Underwood & Associates, llc

August 10th, 2017

RE: PL17-050 Skagit Family YMCA Stormwater and Parking

DESIGN REVISION - 8.4.2017

PROJECT: 1901 HOAG ROAD
MOUNT VERNON, WA 98273
SITE PLAN

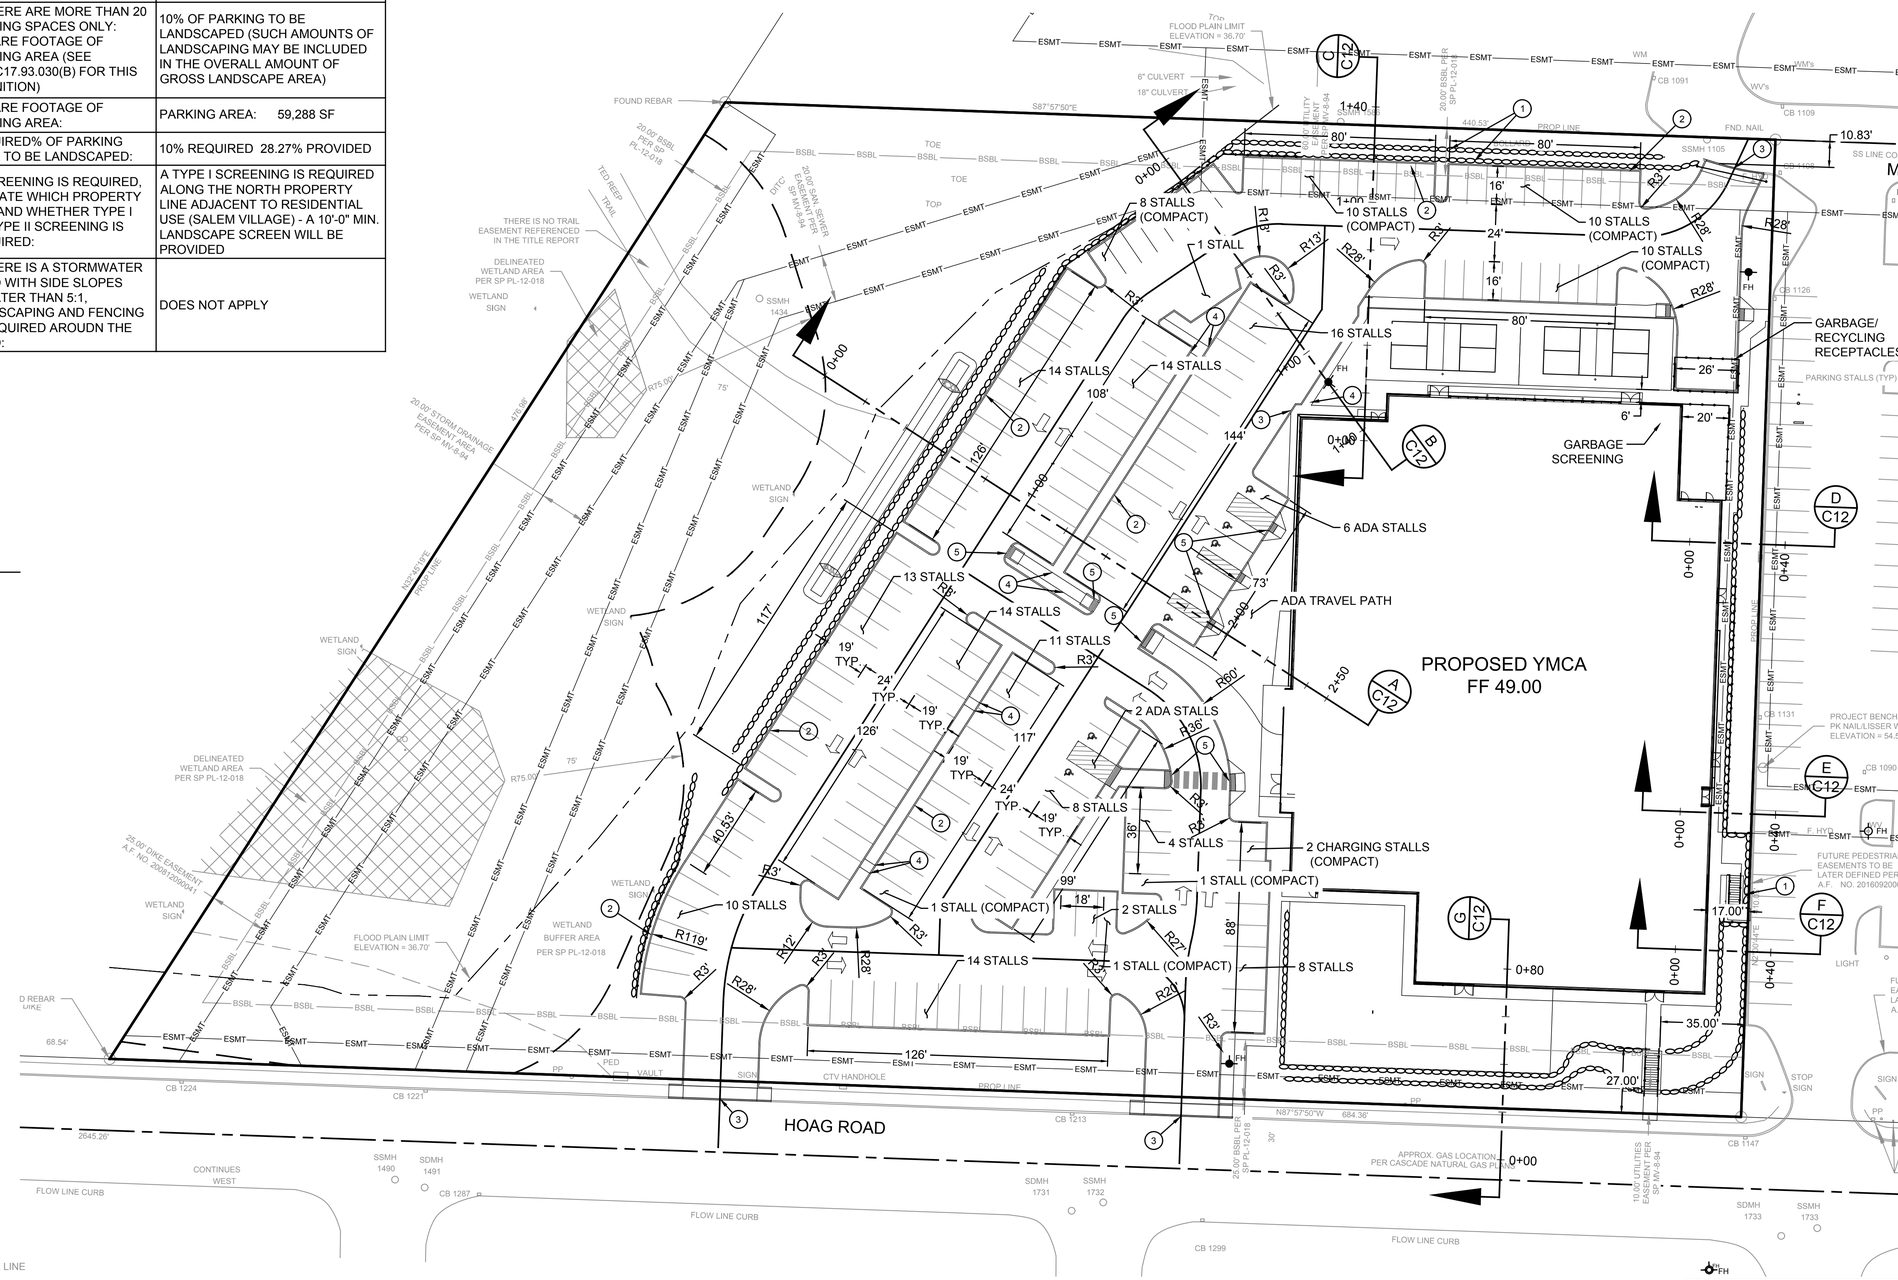
The Board has decided to reduce the square footage of the YMCA facility by eliminating the ELC facility (4,800 sf) and reducing the designated healthcare space from 2,200 sf to 1,600 sf. The total square footage is now 57,116 sf, including 1,600 sf for the healthcare component.

The proposed revised site plan provides **43 compact spaces and 137 standard stall** spaces for a total of **180 stalls on site**. 25% of which are allowed to be compact (45 stalls) – requirement met.

Per this proposed revised site plan, the YMCA **exceeds** the required parking by 12 stalls.
